**ALBERTA TRANSPORTATION
SPRINGBANK OFF-STREAM RESERVOIR
PROJECT
Response to NRCB and AEP
Supplemental Information Request 2,
dated November 18, 2019**

Prepared for:
Alberta Transportation

Prepared by:
Stantec Consulting Ltd.

April 2020

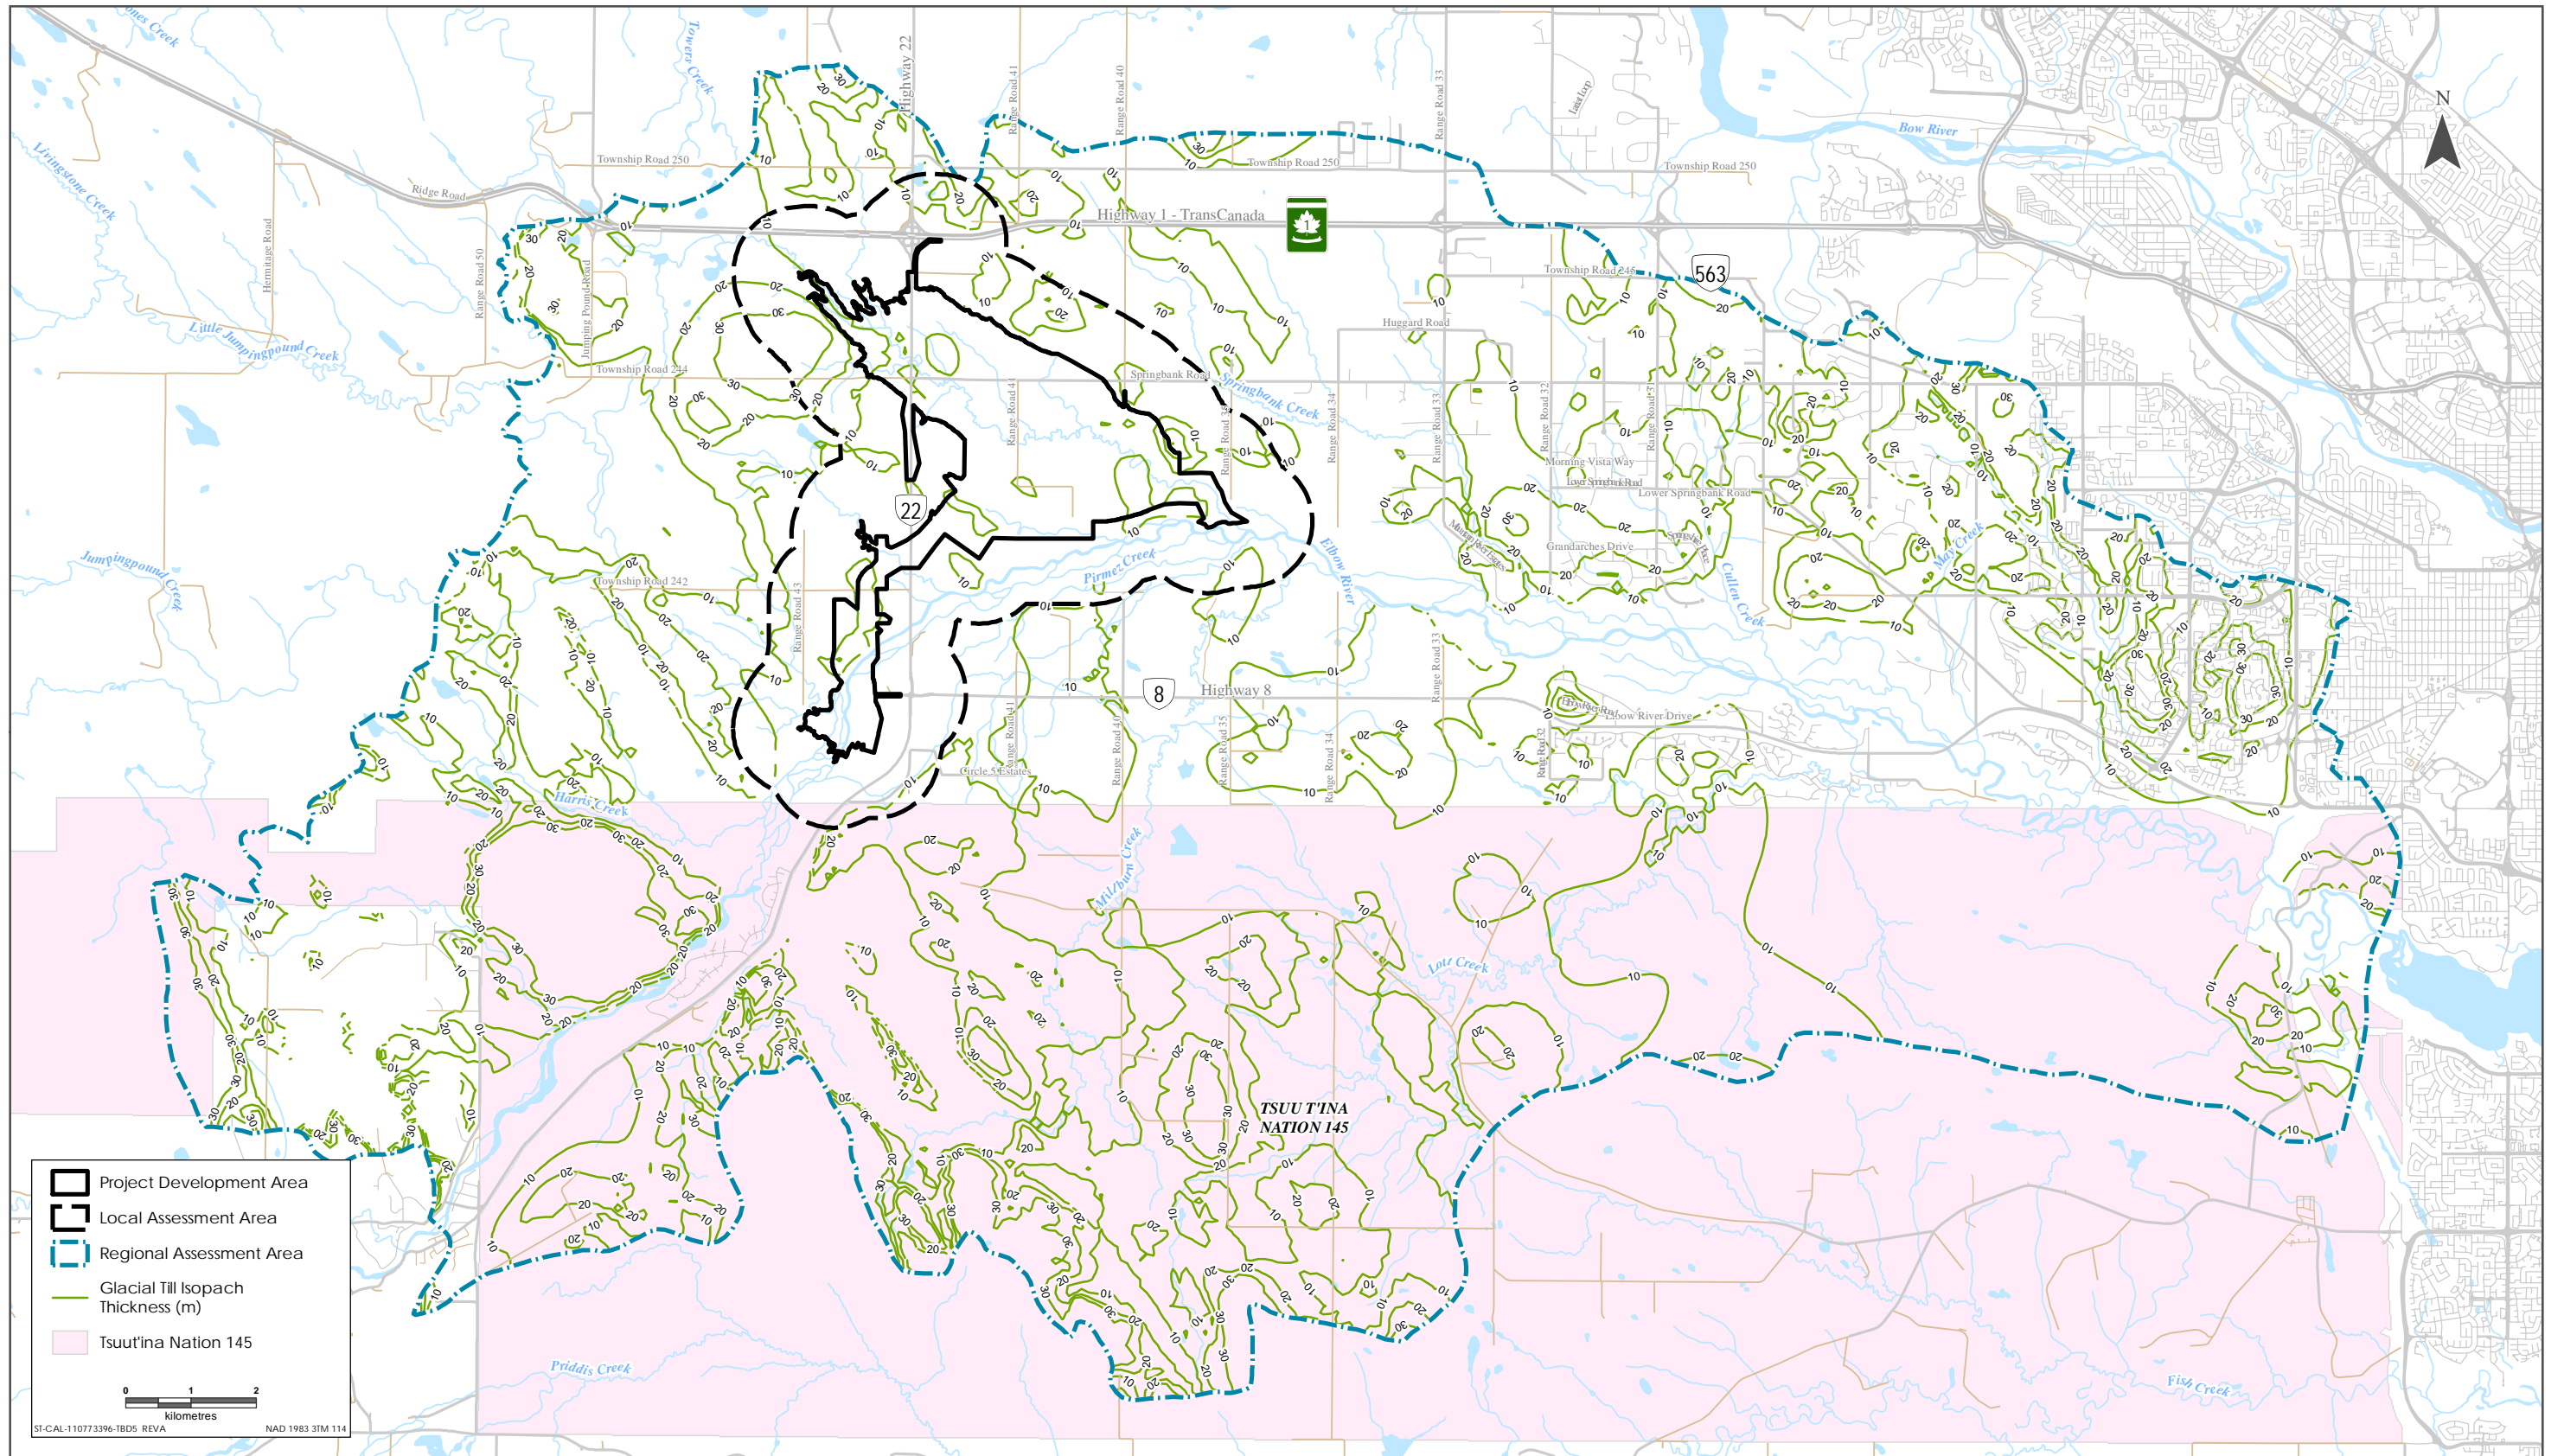
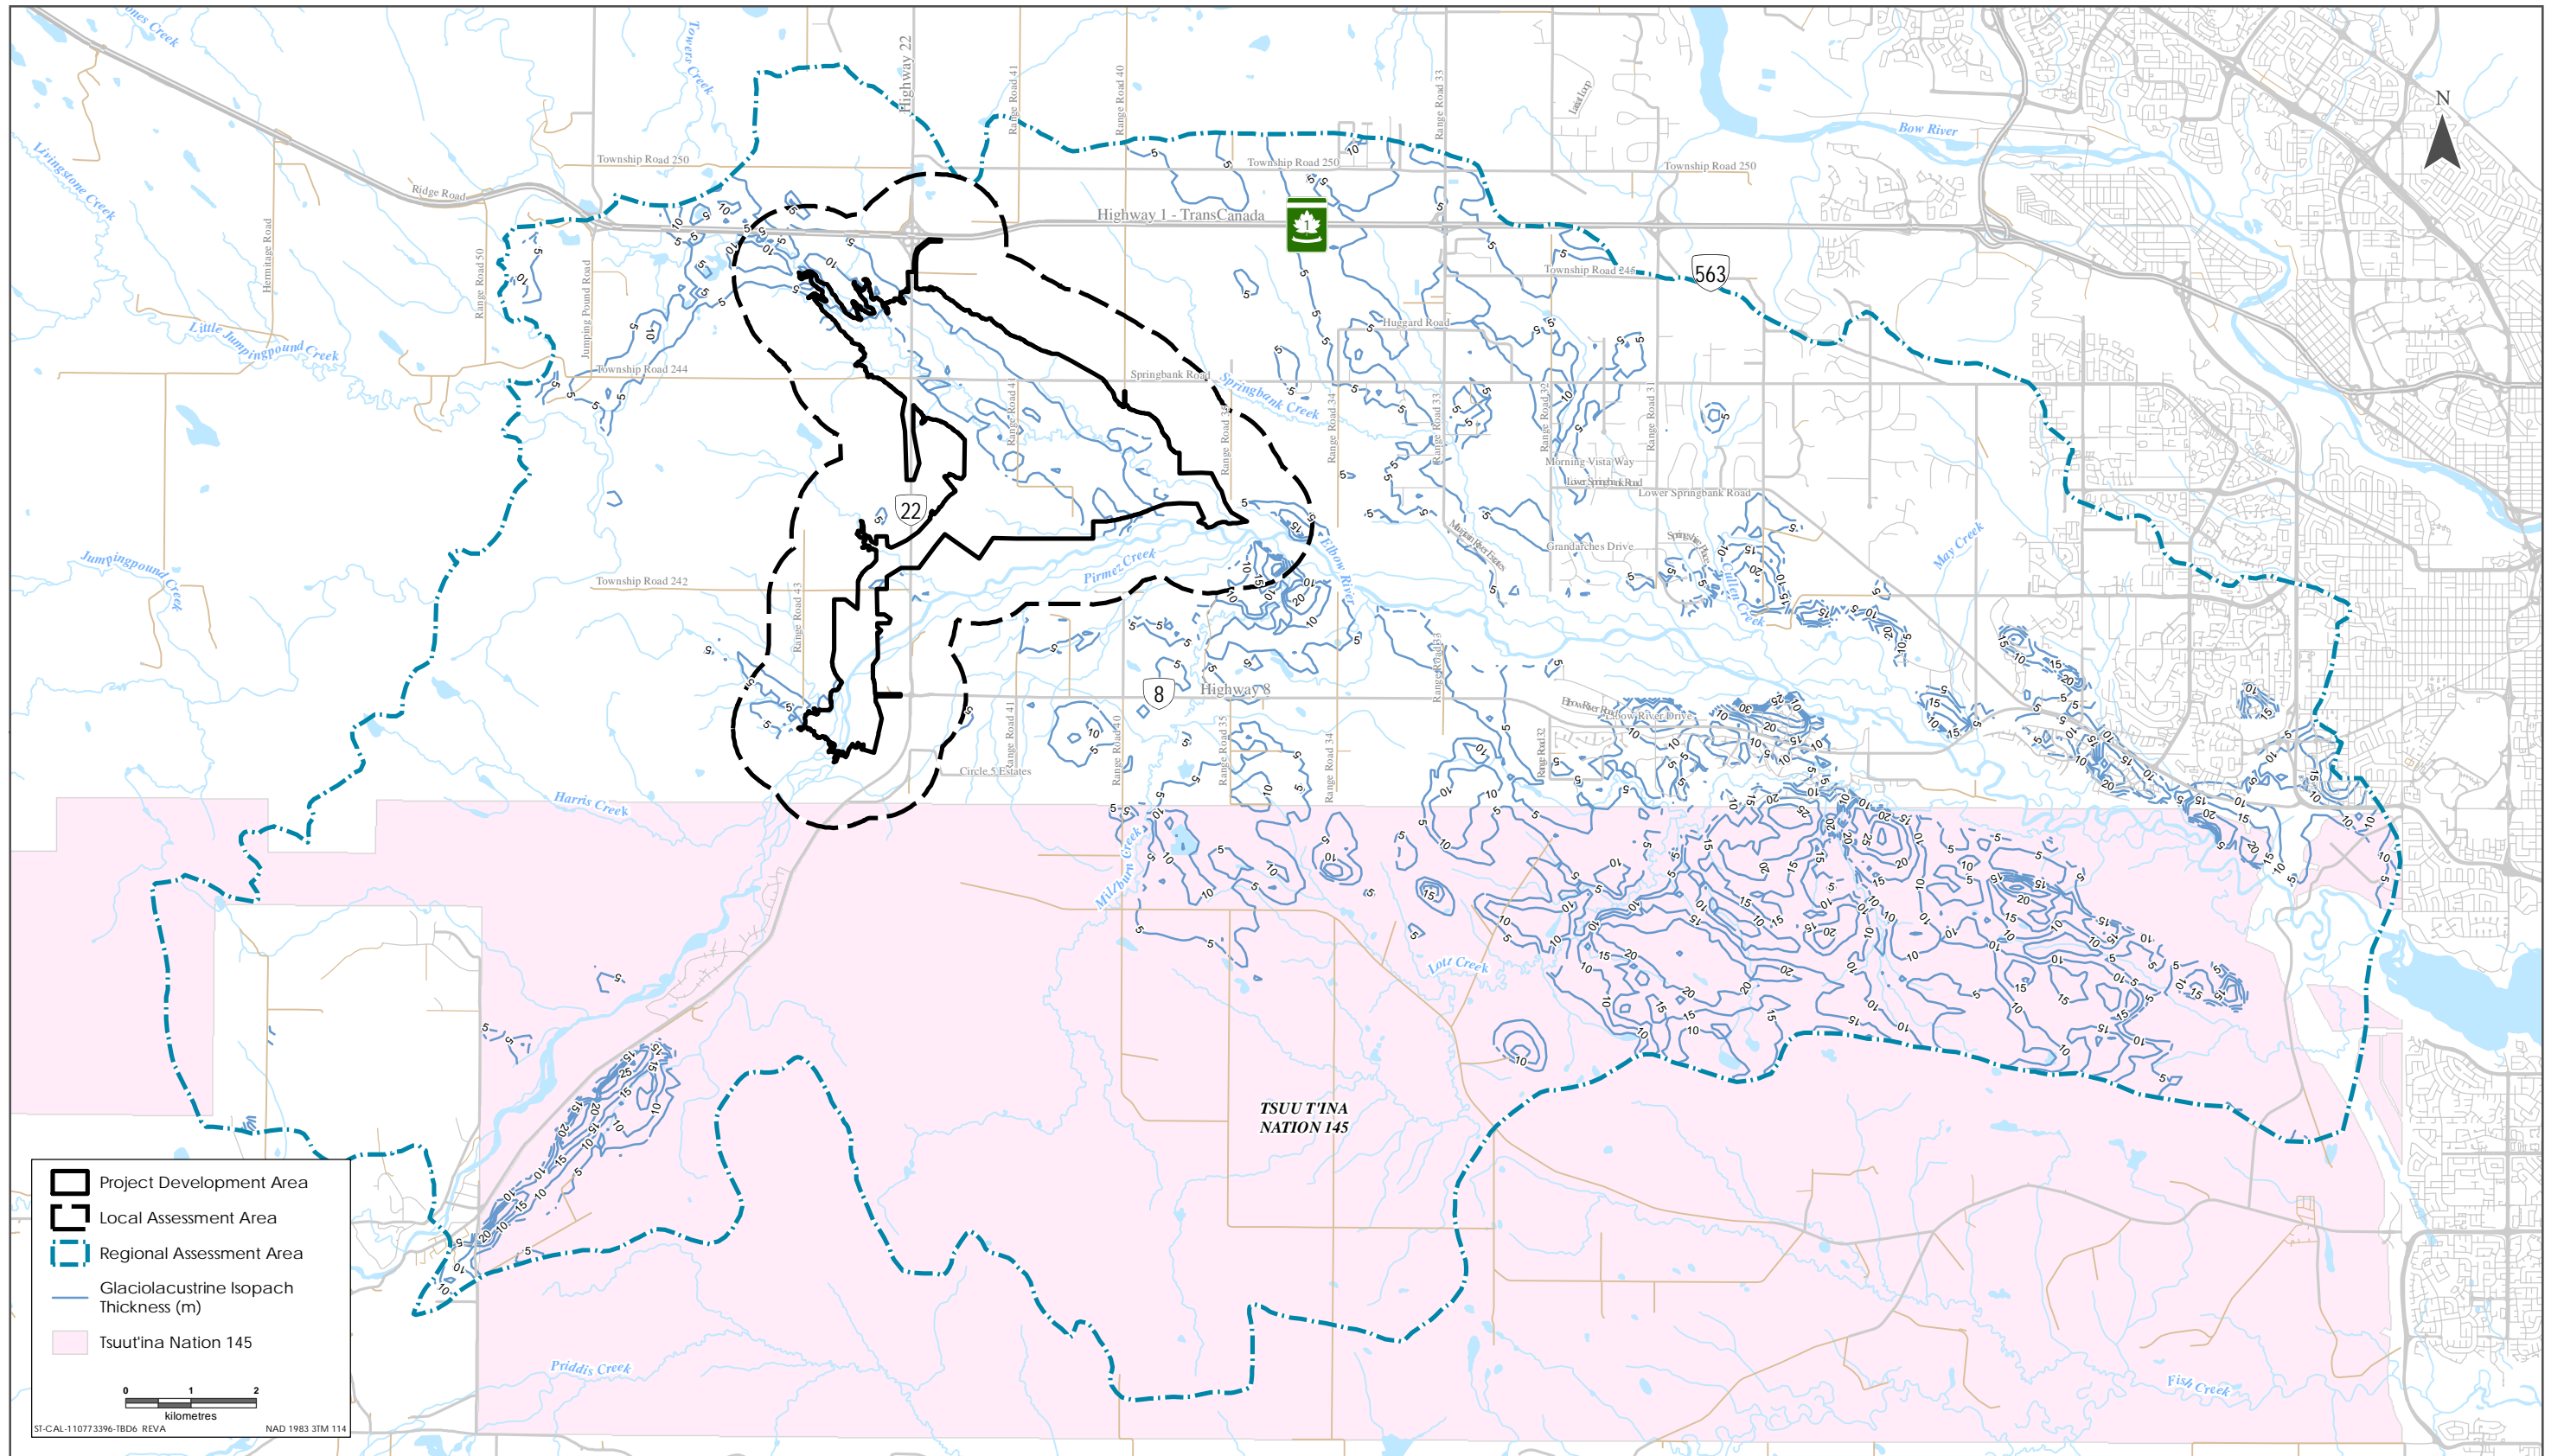
Figures 3-8, 3-10 and 3-12 in Appendix IR42-1 show isopach maps for glacial till, glaciolacustrine, and recent fluvial deposits. Contour labels are not shown for all areas in the expanded RAA and it is not obvious what they are.

- a. Provide the missing labels for the isopach contours in the expanded RAA.**

- a. The contour labels in Alberta Transportation's response to Round 1 Natural Resources Conservation Board (NRCB) information request (IR)42-1, Appendix IR42-1, Figures 3-8, 3-10 and 3-12 have been revised in the following figures: Figure 5-1, Figure 5-2, and Figure 5-3.
